SERVICE BULLETIN

Subject: TS30 Acumen Module Improvement

Bulletin No: TS30-FC-2305

Vehicle Model: TS30 EPA21

Improvement Steps:

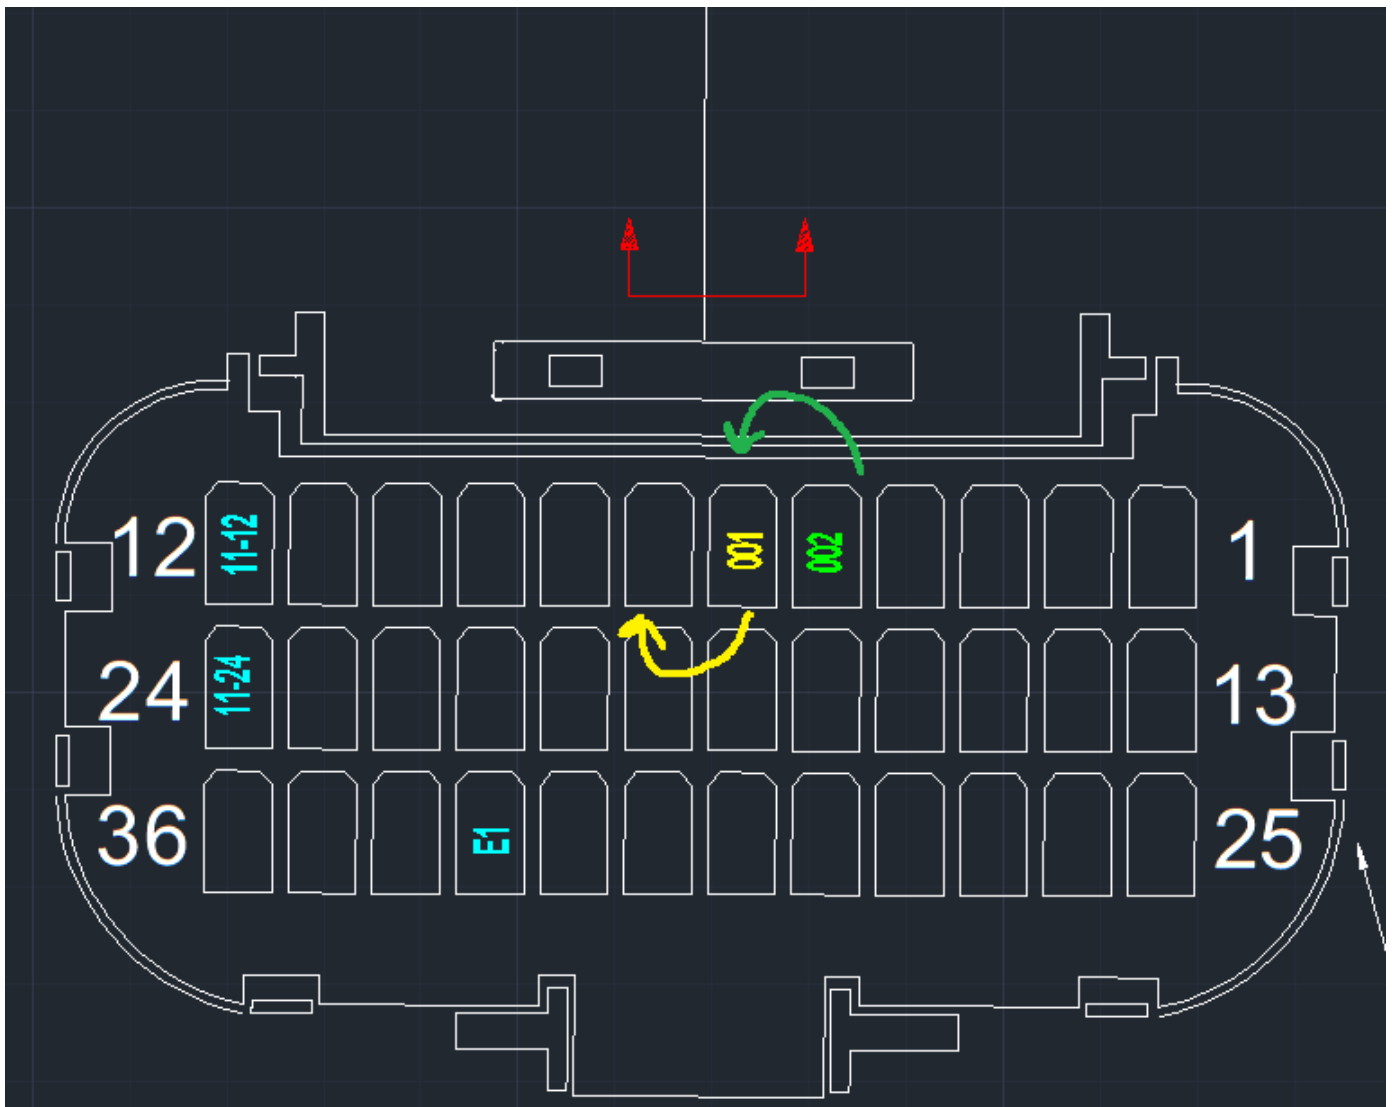
The purpose of the bulletin is Improve the can line connection at the Acumen Module connector.

- 1- Open the dashboard compartment cover located near the vehicle's steps.
- 2- Locate the Acumen Module behind the cover.
- 3- Disconnect the module's connector; it will have 5 cables connected to it.
- 4- Relocate the yellow cable labeled as "001" from pin 6 to pin 7.
- 5- Relocate the green cable labeled as "002" from pin 5 to pin 6.
